28 June 2017
File No. 129611-002

RESPONSE TO COMMENTS

SUBJECT: Responses to the Missouri Department of Natural Resources (MDNR)
23 May 2017 Comments Letter
Leeds – Northern Parcel, Kansas City, Missouri

Figure showing the proposed soil vapor and shallow groundwater monitoring well locations

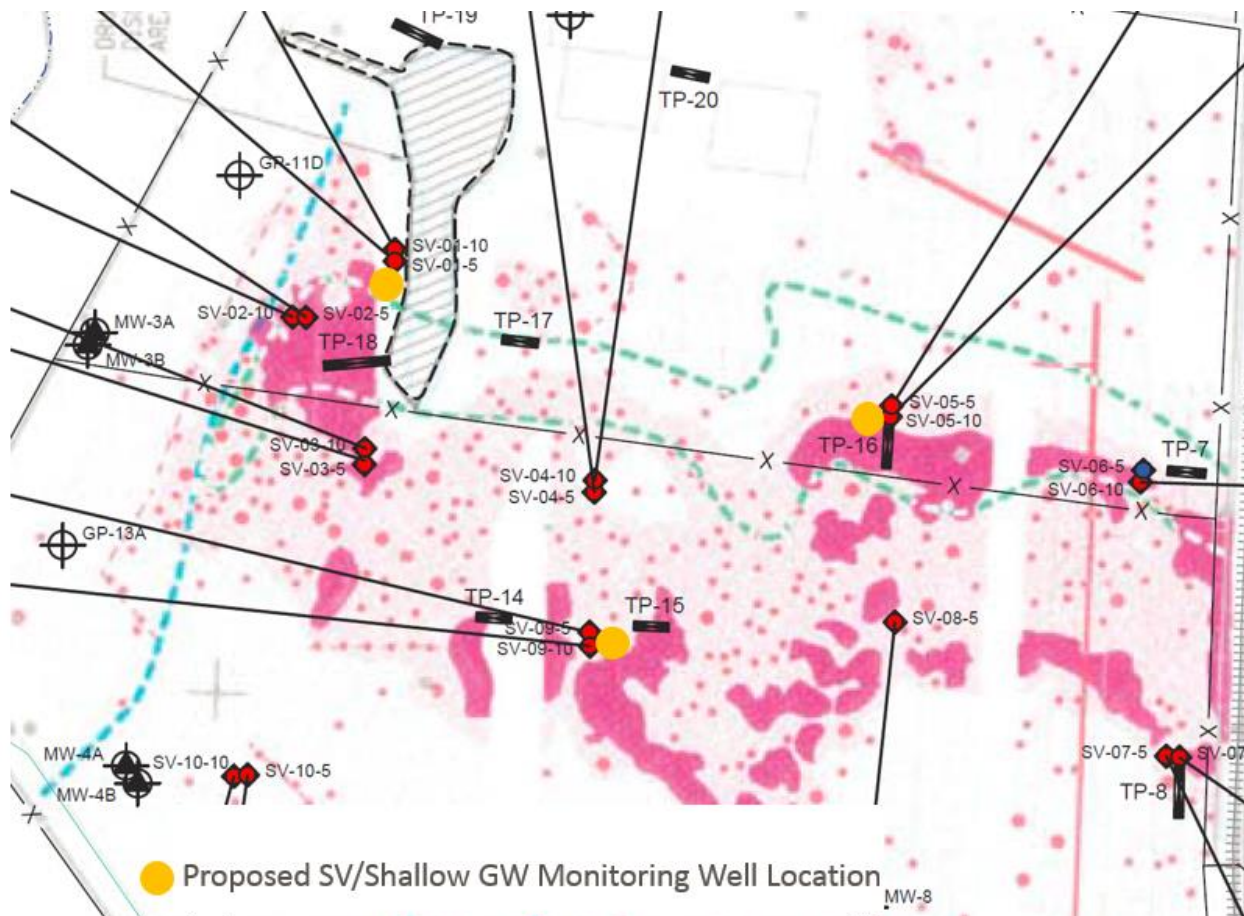
Additional Comment from Dennis: Is soil vapor causing issues on neighboring properties? Is there potential that utility corridors may be creating a soil vapor issue at the Rail Loading Building? What restrictions may be necessary on this property or neighboring properties?

23 May 2017 Comment: Recommend the collection of additional data as necessary to determine the extent of soil vapor impacts and whether it is a concern to neighbors, on-site workers.

17 August 2017 H&A Response: These are topics that will need to be discussed further with the collection of additional data and research into potential utility corridors at the site.

28 June 2017 H&A Response: Additional collection of soil, groundwater, and soil vapor samples are proposed in the fill area.
